LAND USE APPLICATION COMPLETENESS REVIEW

Subject Property: 1105 Front Street NE

Reference Nos.: 24-106451-PLN (Class 3 Site Plan Review, Tentative Subdivision Plan, Class 1 & 2 Adjustment, Class 2 Driveway Approach Permit)

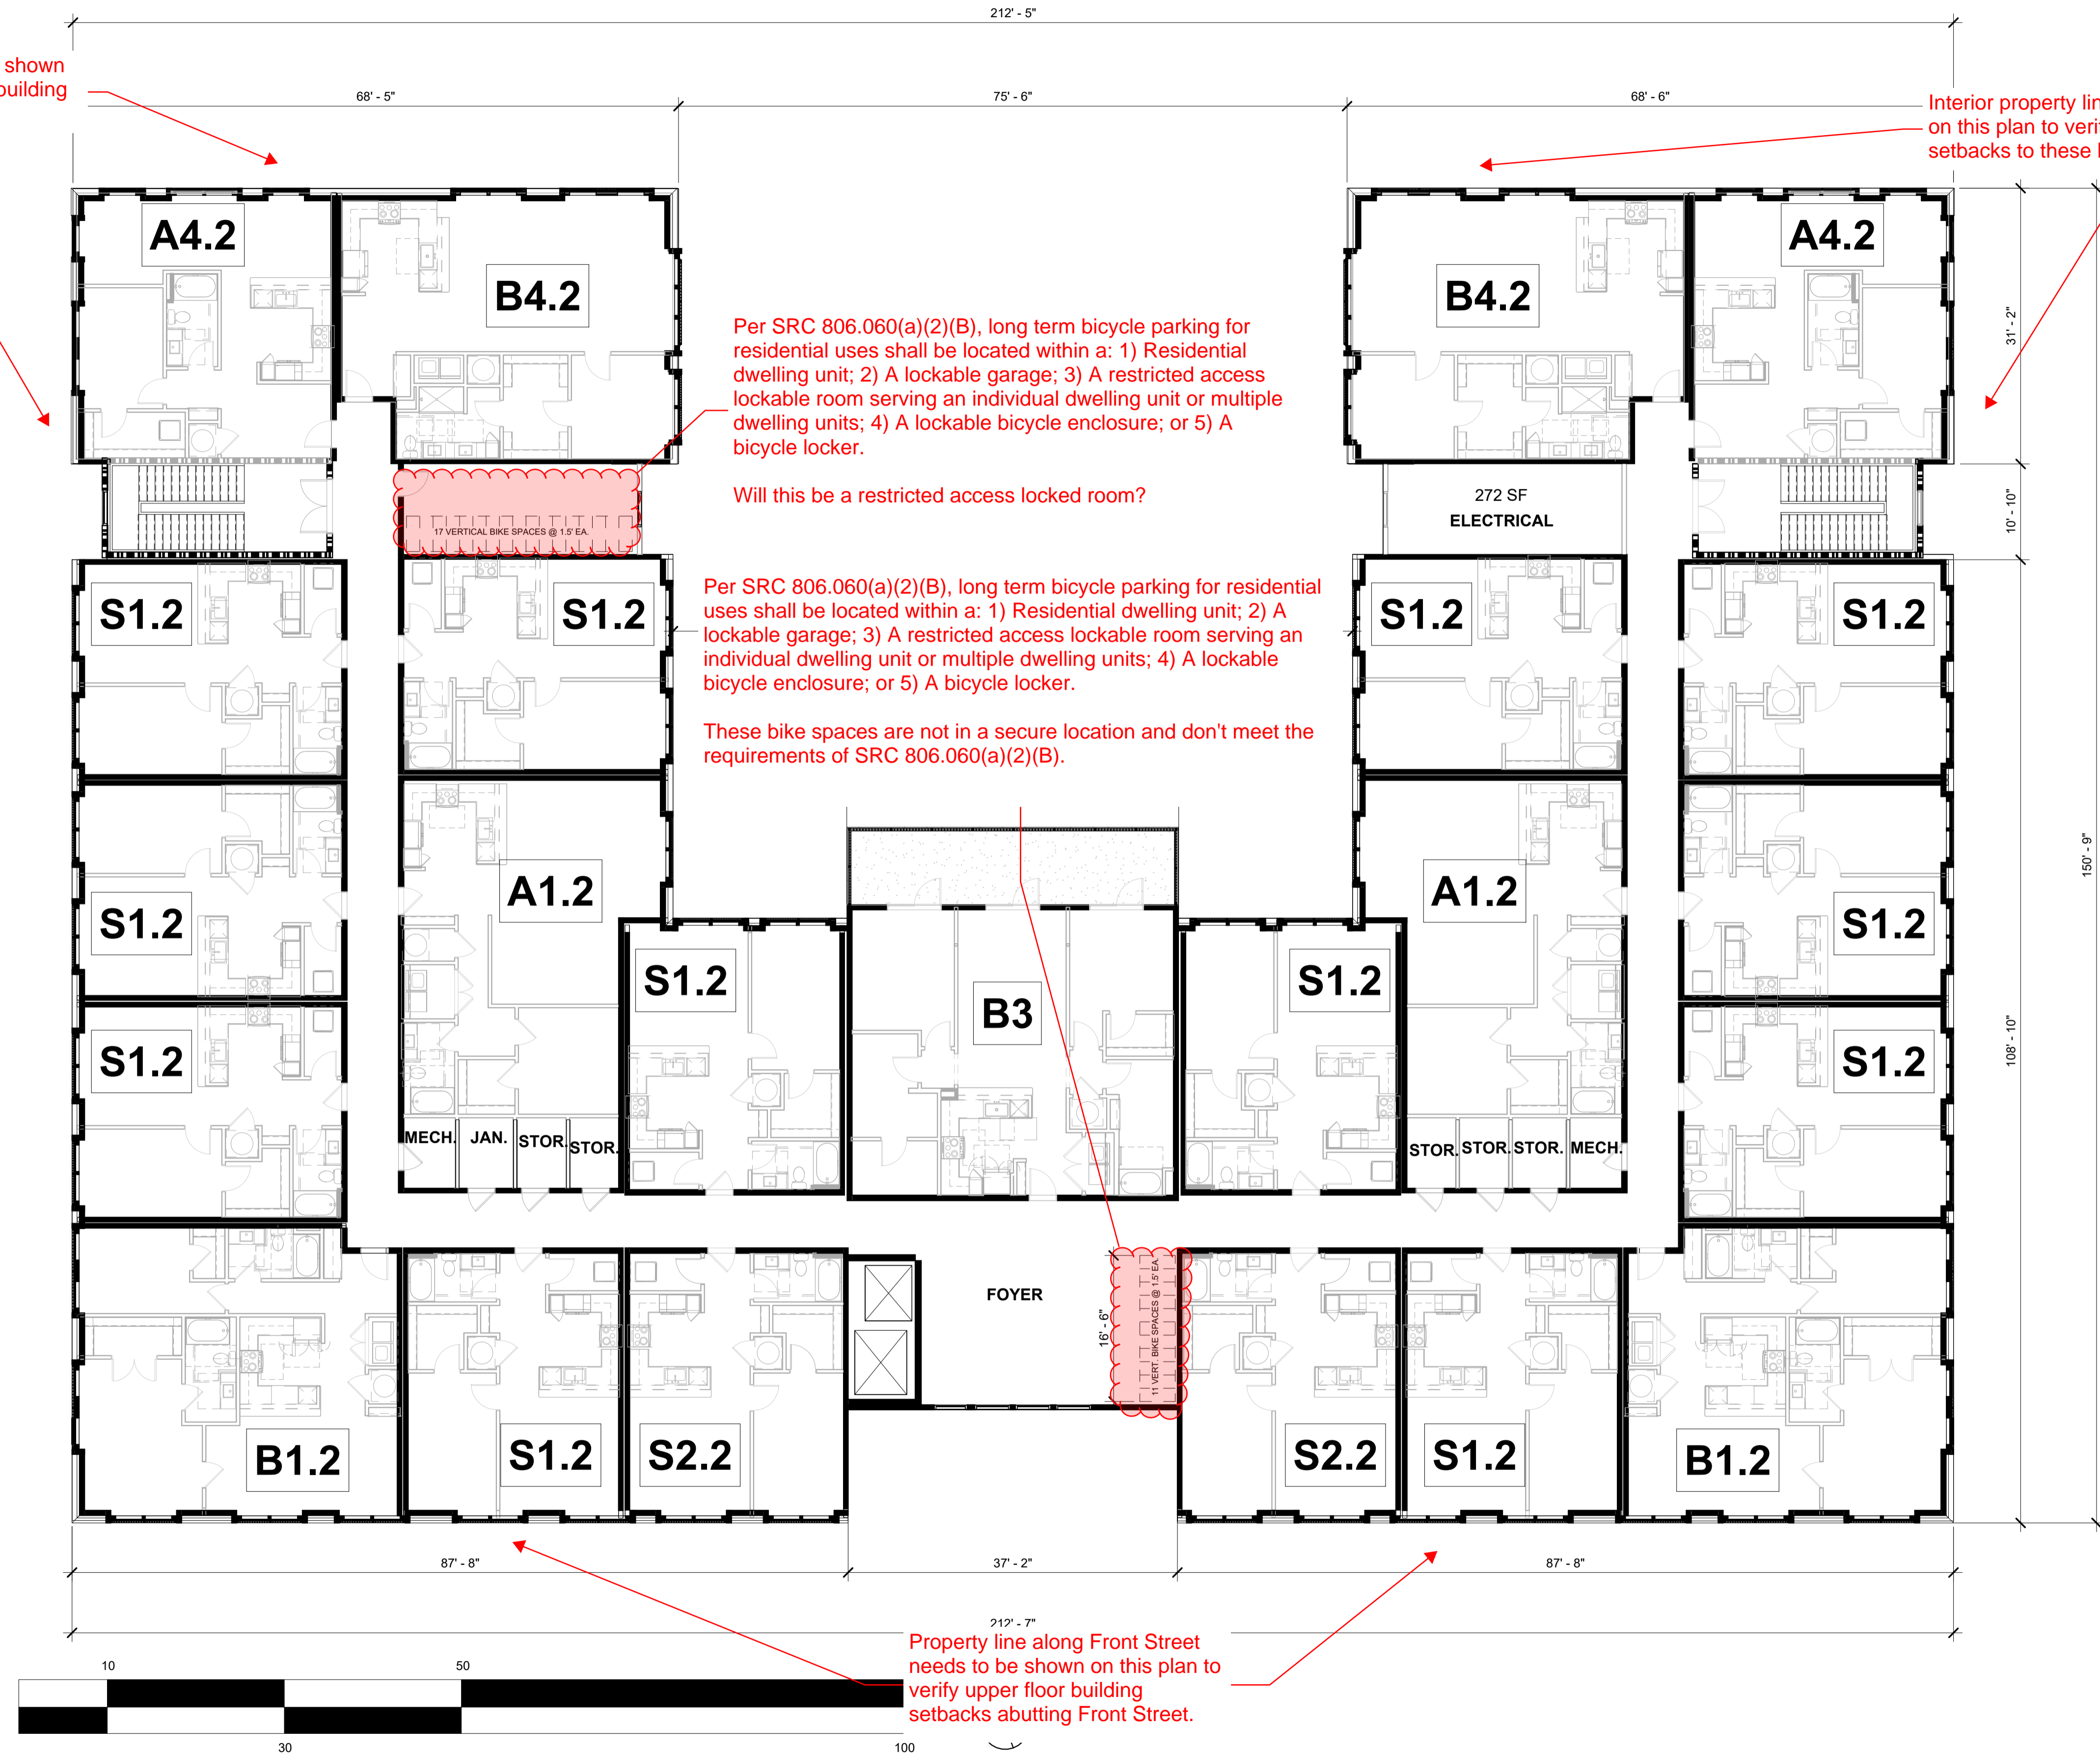
Per SRC 806.060(a)(2)(B), long term bicycle parking for residential uses shall be located within a: 1) Residential dwelling unit; 2) A lockable garage; 3) A restricted access lockable room serving an individual dwelling unit or multiple dwelling units; 4) A lockable bicycle enclosure; or 5) A bicycle locker.

These bike spaces are not in a secure location and don't meet the requirements of SRC 806.060(a)(2)(B).

Property line along Front Street needs to be shown on this plan to verify upper floor building setbacks abutting Front Street.

Interior property lines need to be shown on this plan to verify upper floor building setbacks to these lines.

Interior property lines need to be shown on this plan to verify upper floor building setbacks to these lines.

1 FOOD HALL
3/32" = 1'-0"

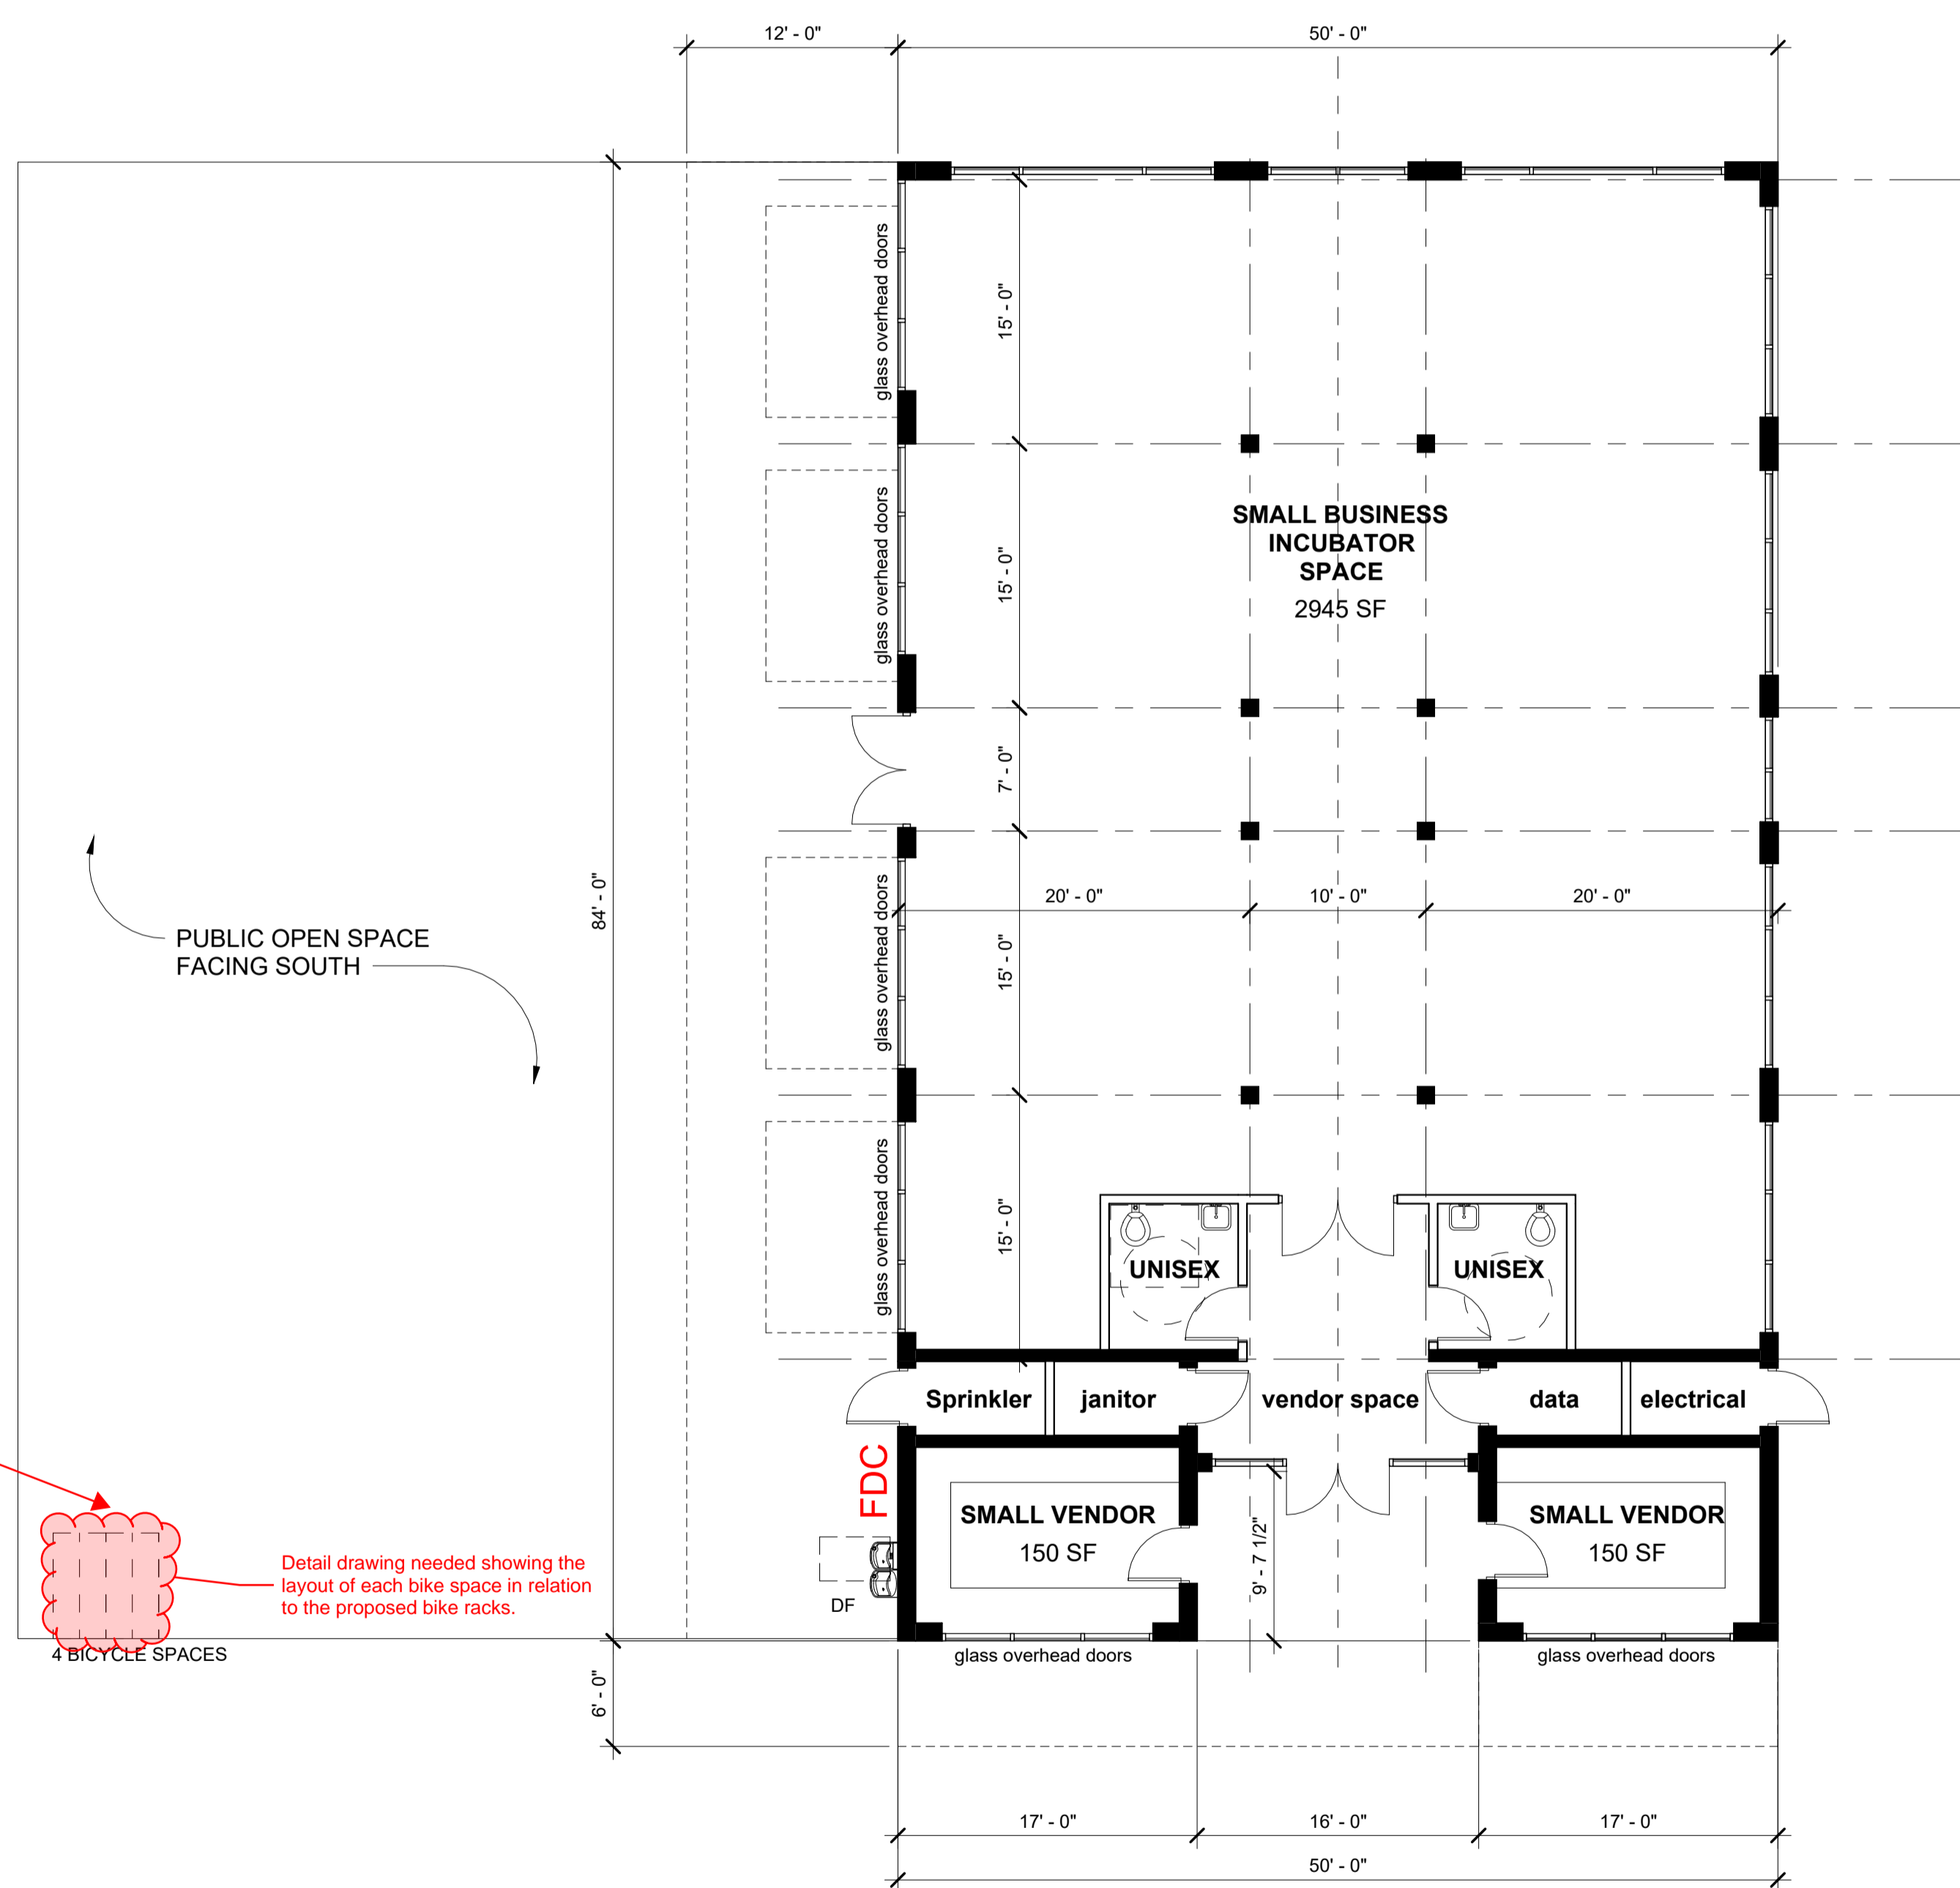
Property line along Front Street needs to be shown on this plan to verify upper floor building setbacks abutting Front Street.

Per SRC 806.060(a)(1), short-term bicycle parking shall be located within a convenient distance of, and be clearly visible from, the primary building entrance. In no event shall bicycle parking be located more than 50 feet from the primary building entrance, as measured along a direct pedestrian route.

Detail drawing needed showing the layout of each bike space in relation to the proposed bike racks.

Per SRC 806.060(a)(1), short-term bicycle parking shall be located within a convenient distance of, and be clearly visible from, the primary building entrance. In no event shall bicycle parking be located more than 50 feet from the primary building entrance, as measured along a direct pedestrian route.
